# The Town of Hilton Head Island Regular Design Review Board Meeting

**The Town of Hilton Head Island**  
**DESIGN REVIEW BOARD**  
**Minutes of the Tuesday, April 12, 2011 Meeting**      **DRAFT**  
**1:15pm – Benjamin M. Racusin Council Chambers**

**Additions and Modifications / Phase III**  
**FIRST PRESBYTERIAN CHURCH**  
Hilton Head Island, SC

## DESIGN TEAM/ DRB COMMENT SHEET

SHEET NUMBER  
**L4**

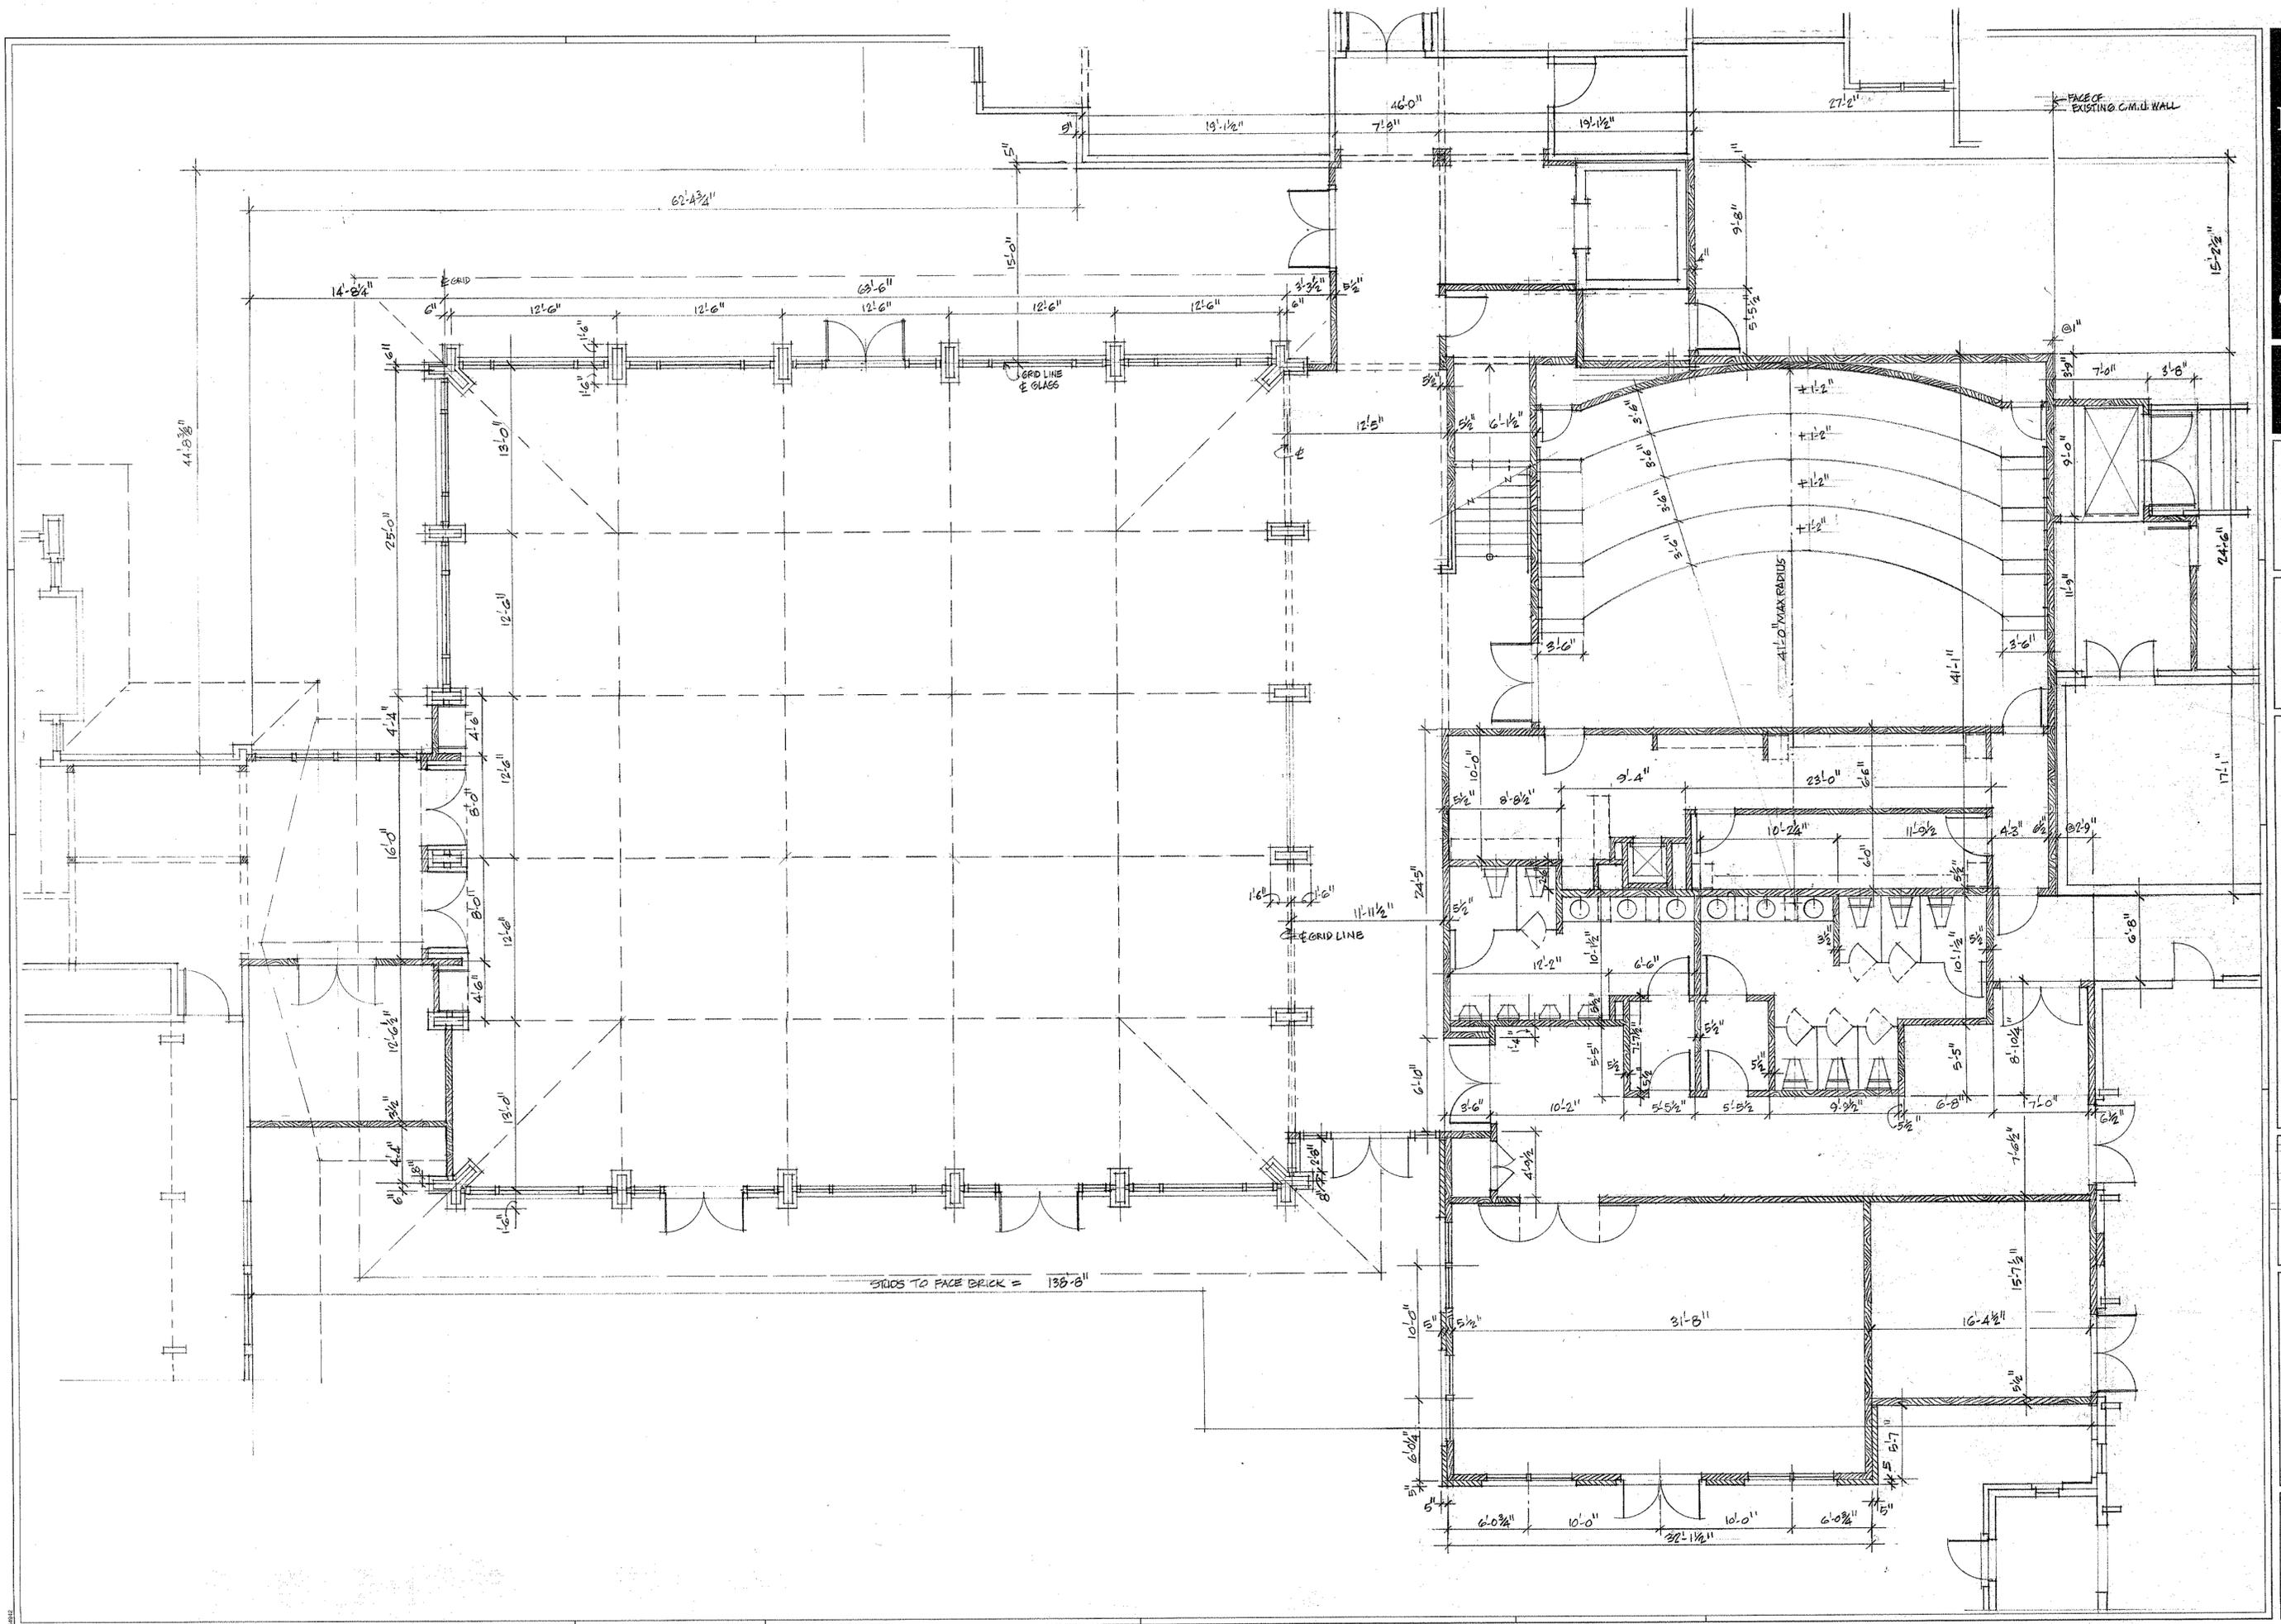
Native plants or plants that have historically been prevalent on the Island are utilized	Y	
A variety of sizes is selected to create a "layered" appearance for visual interest and a sense of depth	Y	
The location of existing mature trees is taken into account in placement of shrubs so as not to damage tree roots	Y	Placement of azaleas in the field around 19/24 Live Oak should be done to minimize root disturbance
Proper spacing and location for plants to reach their mature size and natural	Y

DESIGN GUIDE/LMO CRITERIA	COMPLIES YES/NO/NA	COMMENTS OR CONDITIONS
An effort has been made to preserve existing trees and under story plants		Because of significant/specimen live oaks in the area where the dumpster is proposed (between existing buildings), Natural Resources will require alternates for asphalt and conventional concrete (such as pervious concrete)that can be installed on top of existing grade in this area, and/or a reduction in paving to accommodate tree roots.  In areas where large, mature trees are retained, arrange new landscaping to minimize root damage (i.e. at dripline or beyond).
Supplemental and replacement trees meet LMO requirements for size, species and number		
Wetlands if present are avoided and the required buffers are maintained		
Sand dunes if present are not disturbed
